# Access Compliance Report

## Public Rights-of-Way

### (Curb Ramps)

Intersection ID: 9356	Main Street: E_36TH_ST	Cross Street: N_TRYON_ST	Location: SW
ADA ID: 64B2ACA0D407	Ramp Type: Perp	Initial Pass/Fail: Fail	Overall Compliance: No
		Severity Score: 42.5

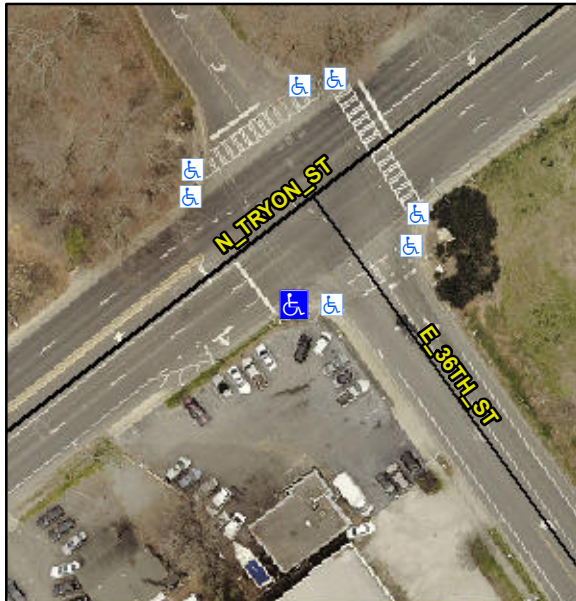
**Not Found, R304.5.1, R304.2.2, R304.5.3**

Compliance	Description	Data	Compliance	Description	Data
N/A	Ramp Length (in)	60.0	No	Ramp Slope (%)	9.2
No	Ramp Width (in)	35.5	No	Ramp XSlope (%)	5.3
N/A	Flare Type LT	N/A	N/A	Flare Type RT	N/A
N/A	Flare Slope LT (%)	N/A	N/A	Flare Slope RT (%)	N/A
N/A	Flare Traversable LT?	N/A	N/A	Flare Traversable RT?	N/A
N/A	Landing Length (in)	N/A	N/A	DWS Provided?	N/A
N/A	Landing Width (in)	N/A	N/A	DWS Contrast?	N/A
N/A	Landing Slope (%)	N/A	N/A	DWS Length (in)	N/A
N/A	Landing X Slope (%)	N/A	N/A	DWS Full Width?	N/A
N/A	Landing Curb? (Y/N)	N/A	N/A	DWS Offset (in)	N/A
N/A	Shared Landing?	N/A			
N/A	Gutter Ponding?	N/A	N/A	Gutter Slope (%)	N/A
N/A	Gutter Lip Ht (in)	N/A	N/A	Gutter X Slope (%)	N/A
N/A	Painted X Walk1?	No	N/A	Painted X Walk2?	N/A
	X Walk 1 Direction	To NW		X Walk 2 Direction	N/A
N/A	X Walk 1 Width (in)	N/A	N/A	X Walk 2 Width (in)	N/A
	X Walk 1 Slope (%)	4.2		X Walk 2 Slope (%)	N/A
	X Walk 1 X Slope (%)	4.5		X Walk 2 X Slope (%)	N/A

**Remove & Replace Entire Ramp.**
